2014 FIA FORMULA 3 EUROPEAN CHAMPIONSHIP

Clarification Note N°6 – to all FIA F3 European Championship Competitors

Geneva, 10 April 2014

FIA Formula 3 European Championship Diffusor Trims for Dallara F312-F314 10.04.2014

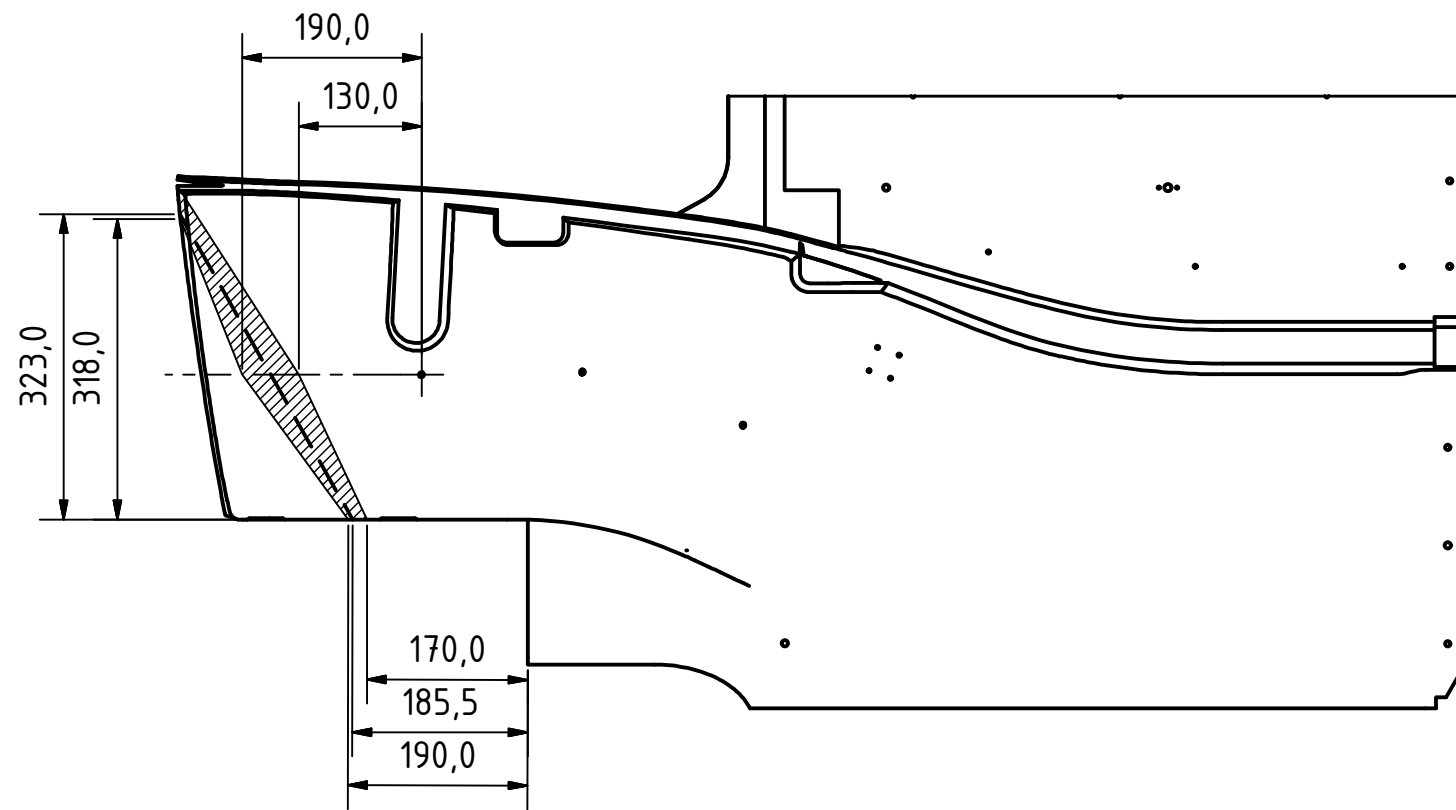
Please find below the drawing of the diffusor trims for Dallara F312-F314

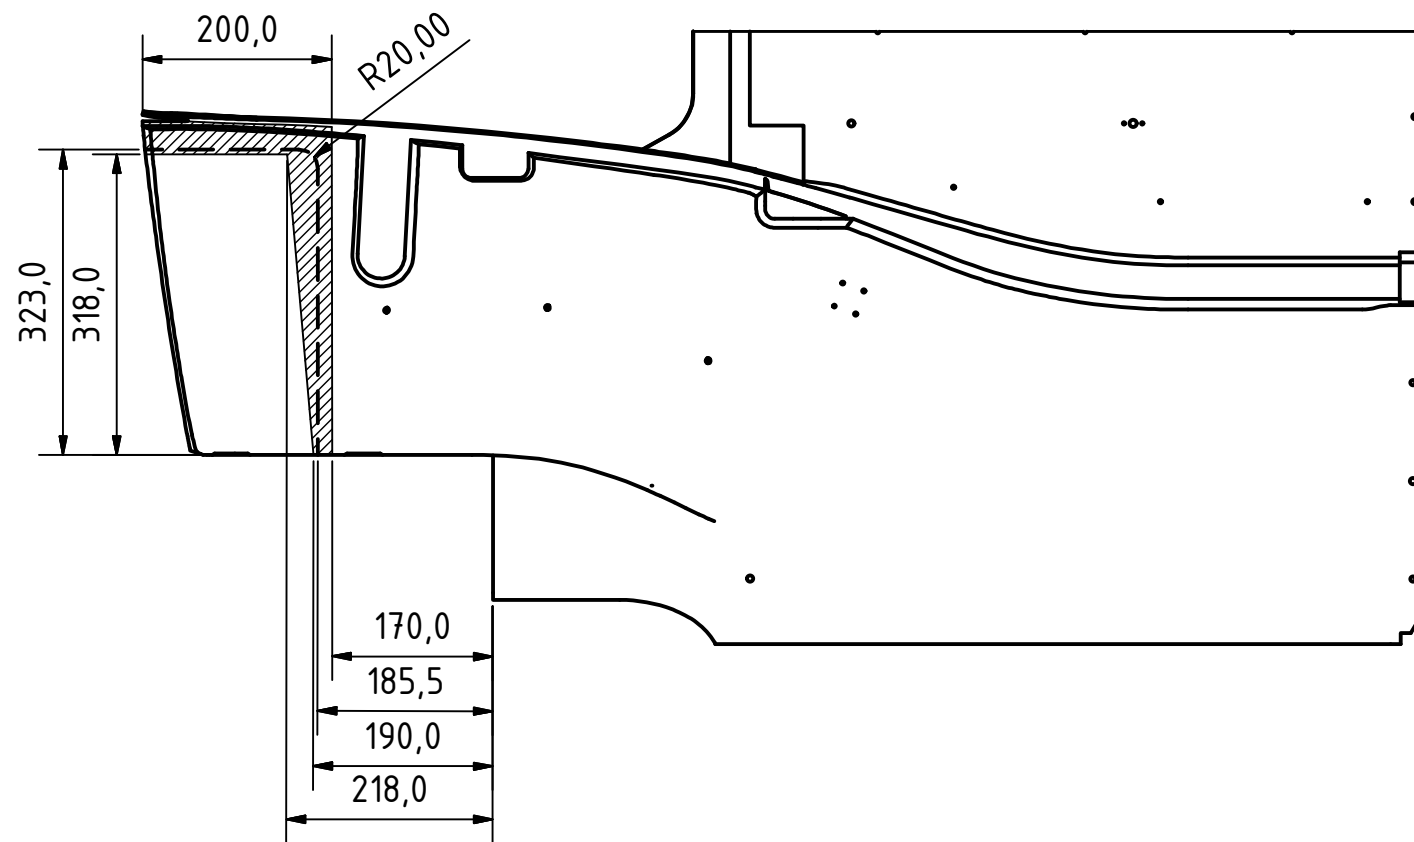
Trim 1

The trim must be a continuous, steady line within the indicated area. Steps, recesses, holes are not admitted.

The diffuser fins may be cut only to bring them in legal condition.

Trim 2
